# LiDAR Quality Assessment Report

AR-FEMA\_Chicot-Desha-LOT1\_2012

FEMA VI Chicot and Desha Lidar

Lot 1 (South Half) of 2 lots.

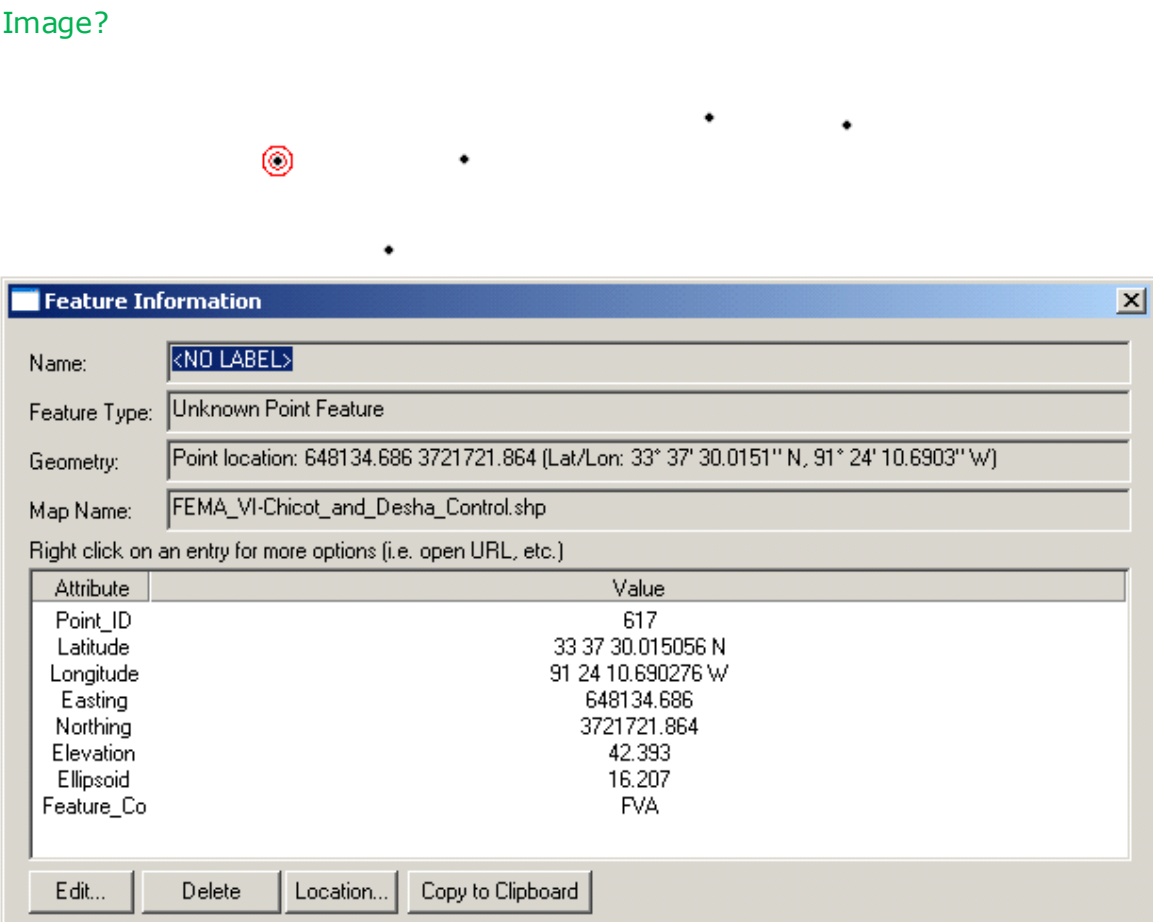
Bare Earth Check Points are labeled in Shape file as FVA instead of Bare Earth (See example above) Will ask contractor to resubmit properly labeled. TO C.1.b.(vii)(b)(5) specifies category labels to use.

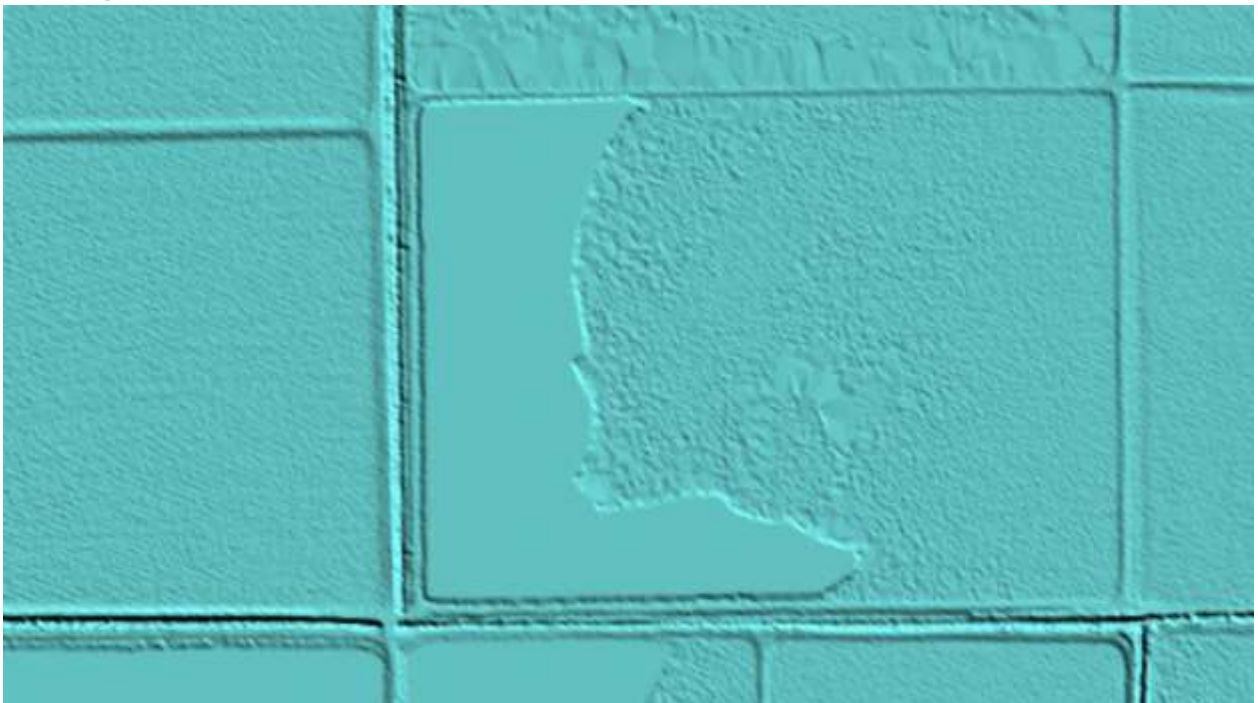
Elevated\_water\_1: There is only one of this type of error. It is located at the following location - 33° 09' 1.7" N, 91° 27' 33.9" W.

\*\*This error was fixed by vendor.

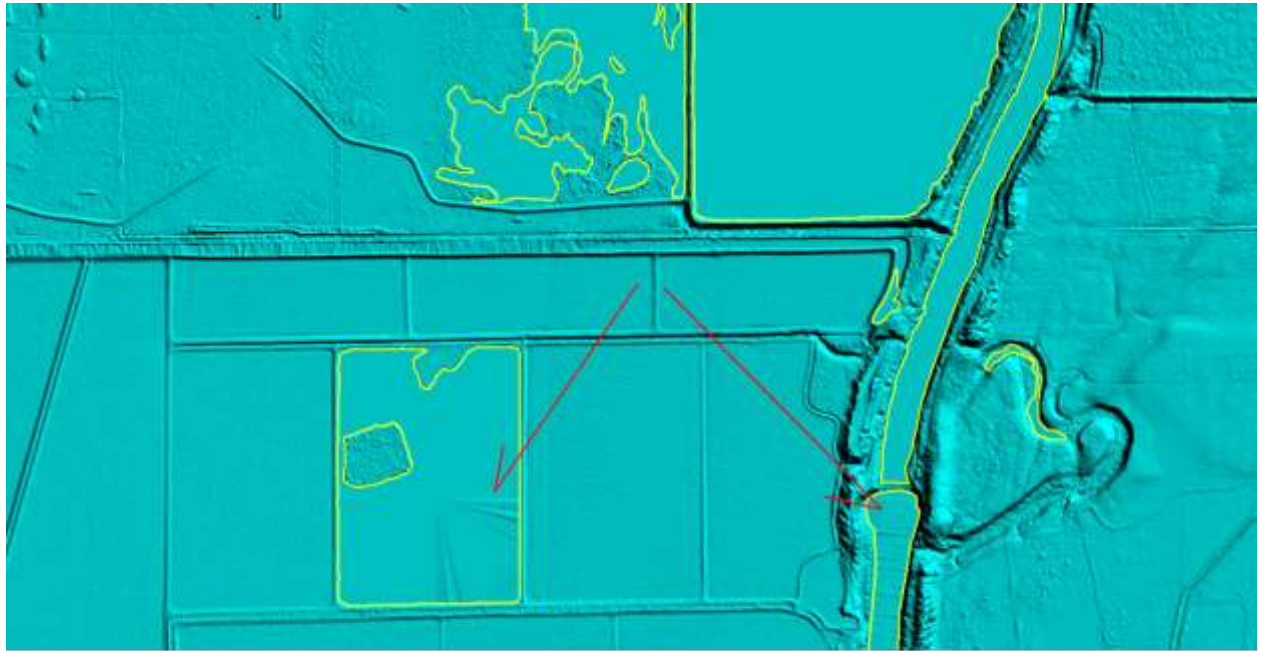
Unflattened\_waterbodies: There are only two water bodies that have "flattening" issues as seen in the image above. They are located around 33° 00' 7.1" N, 91° 26' 30.6" W.

\*\*This error was fixed by vendor.

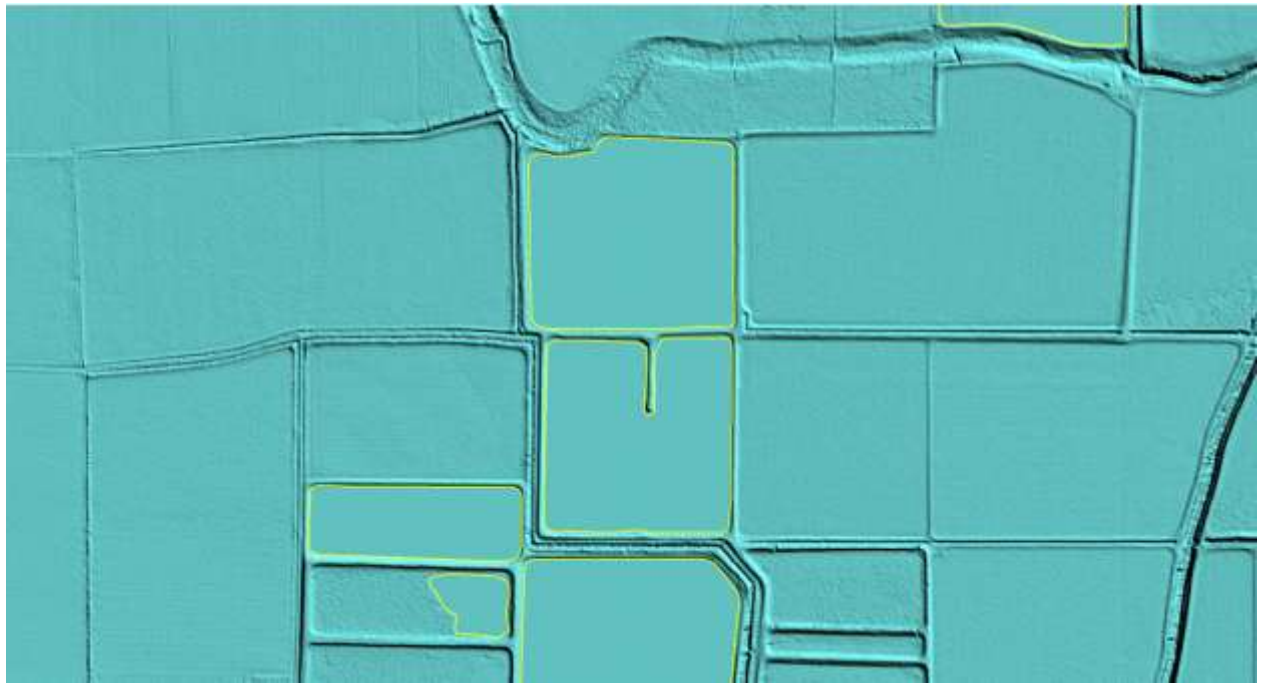
The flattened areas in this image are flooded fields and not ponds (see image below); these were the conditions on the ground at the time of lidar collection. This representative image of these conditions is not being flagged as an error but instead to bring attention to the conditions on the ground at the time of lidar collection.

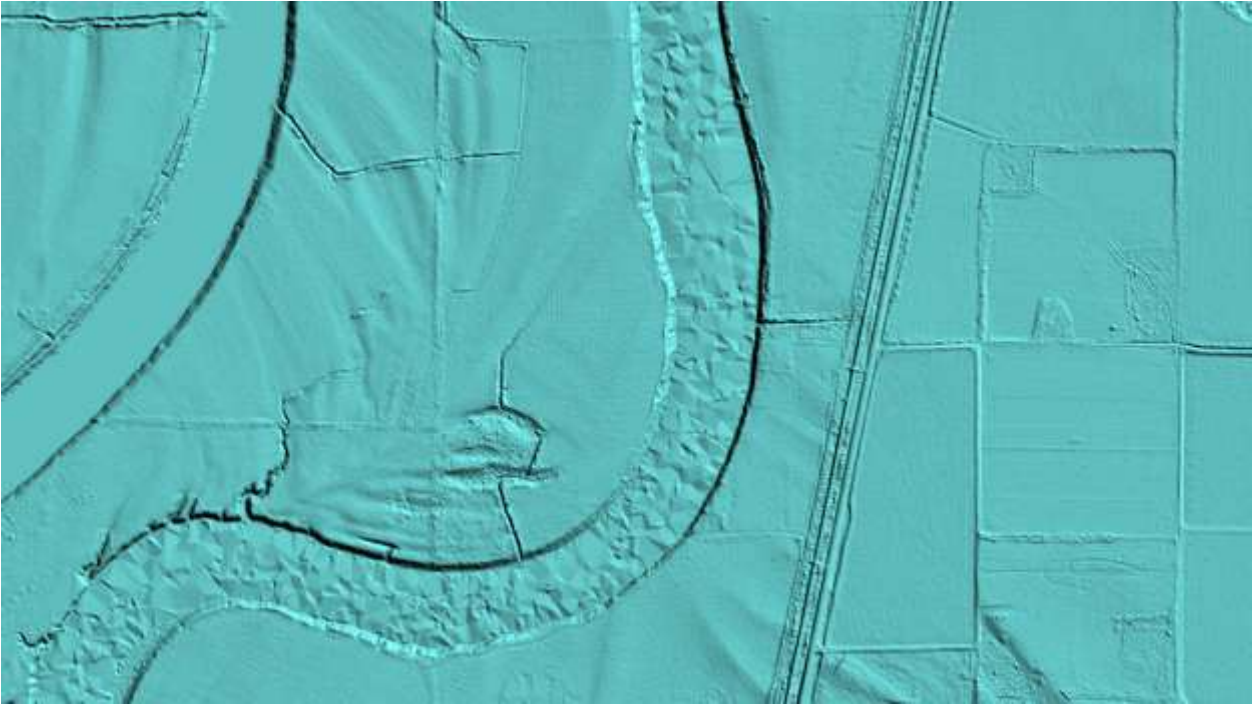
The curved, triangulated waterbody contains vegetation (swamp) and was not hydroflattened. This is not flagged as an error.

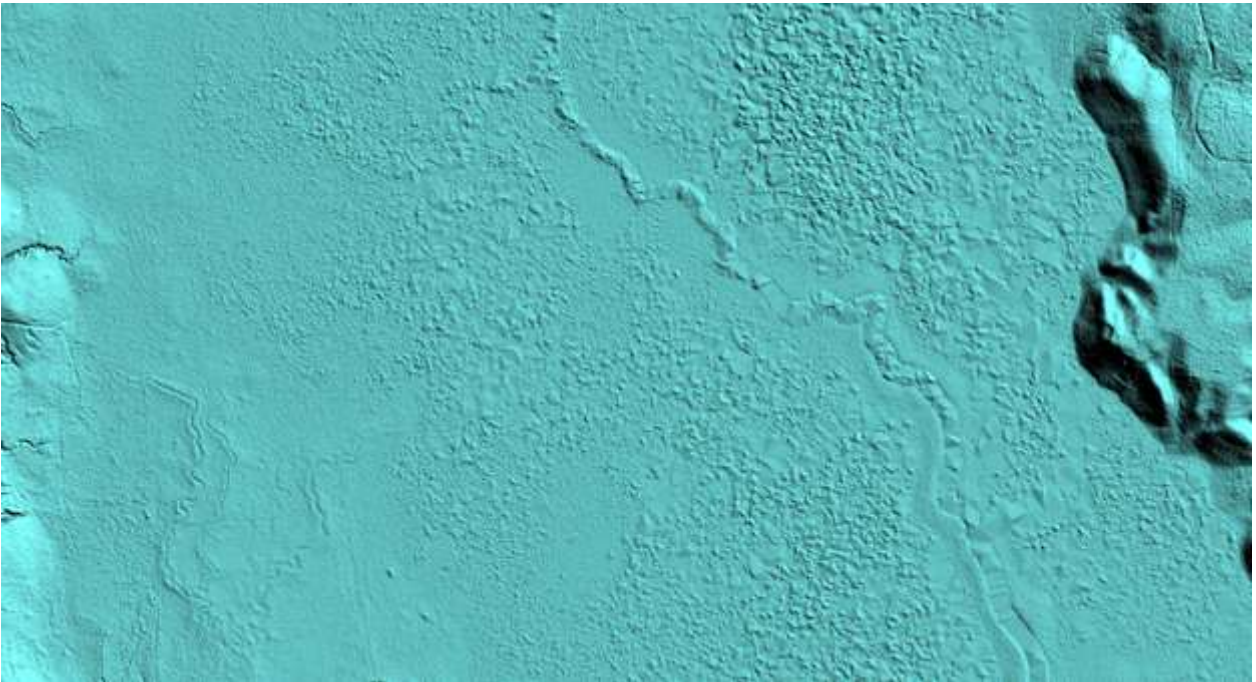
Project boundary is located on the floodplain of the Mississippi River; area is mainly flat and swampy. TINing of the swampy areas may be found throughout the project area. This is not flagged as an error.
